14th February 2012

SKM_VW06459_DHI comments.docx
VW06459

Comments on “Review of Hydraulic Modelling” prepared by DHI for Queensland Flood Commission of Inquiry, 12 February 2012

January 2011 peak level profile estimated using the MIKE11 model versus observed debris flood marks provided by Brisbane City Council.

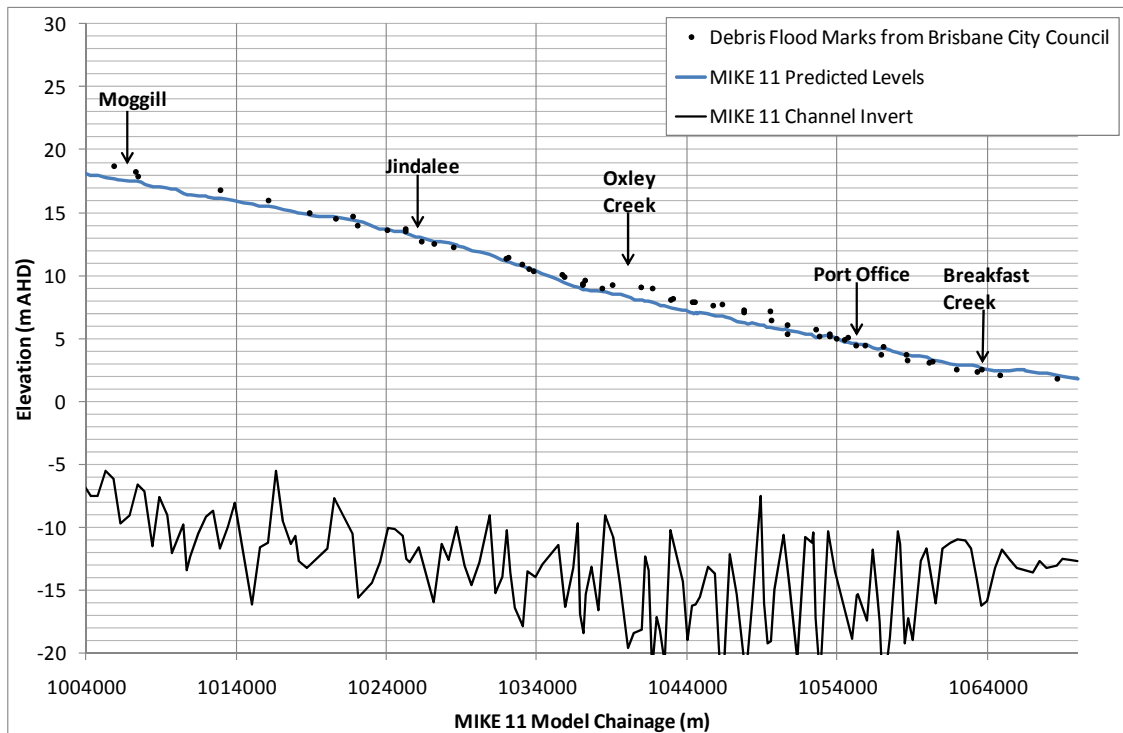
Representation of floodplain storage in Oxley Creek. Limitations around the ability of the model to represent flood levels in the vicinity of Oxley Creek were recognised in the original reporting. As illustrated in the figure below, these limitations have little impact on the ability of the model to reproduce observed flood levels at locations upstream and downstream of this reach. This is primarily due to the fact that the volume of floodplain storage in these tributary

creeks (such as Oxley Creek) is very small in comparison to the volume of flow passing along the Brisbane River in large floods.
